# Access Compliance Report

## Public Rights-of-Way

### (Curb Ramps)

Intersection ID: 11847	Main Street: E_9TH_ST	Cross Street: N_TRYON_ST	Location: S
ADA ID: AE7085CF814D	Ramp Type: Perp	Initial Pass/Fail: Fail	Overall Compliance: No
Severity Score: 12.5			
Codes/Mitigation Info/Possible Solution		Field Measurements/Component Compliance

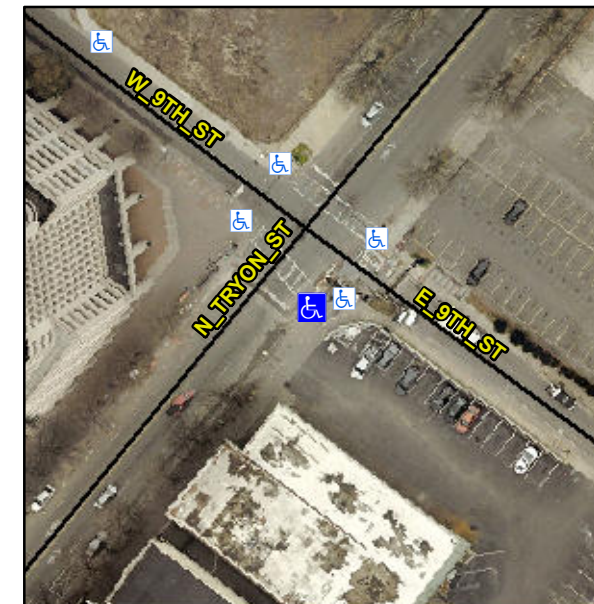
**R304.2.2**

Compliance	Description	Data	Compliance	Description	Data
N/A	Ramp Length (in)	84.0	No	Ramp Slope (%)	10.2
Yes	Ramp Width (in)	48.0	Yes	Ramp XSlope (%)	0.5
N/A	Flare Type LT	N/A	N/A	Flare Type RT	N/A
N/A	Flare Slope LT (%)	N/A	N/A	Flare Slope RT (%)	N/A
N/A	Flare Traversable LT?	N/A	N/A	Flare Traversable RT?	N/A
N/A	Landing Length (in)	N/A	N/A	DWS Provided?	N/A
N/A	Landing Width (in)	N/A	N/A	DWS Contrast?	N/A
N/A	Landing Slope (%)	N/A	N/A	DWS Length (in)	N/A
N/A	Landing X Slope (%)	N/A	N/A	DWS Full Width?	N/A
N/A	Landing Curb? (Y/N)	N/A	N/A	DWS Offset (in)	N/A
N/A	Shared Landing?	N/A			
N/A	Gutter Ponding?	N/A	N/A	Gutter Slope (%)	N/A
N/A	Gutter Lip Ht (in)	N/A	N/A	Gutter X Slope (%)	N/A
N/A	Painted X Walk1?	Yes	N/A	Painted X Walk2?	N/A
	X Walk 1 Direction	To NW		X Walk 2 Direction	N/A
N/A	X Walk 1 Width (in)	120.0	N/A	X Walk 2 Width (in)	N/A
	X Walk 1 Slope (%)	6.9		X Walk 2 Slope (%)	N/A
	X Walk 1 X Slope (%)	2.6		X Walk 2 X Slope (%)	N/A

**Remove & Replace Entire Ramp.**
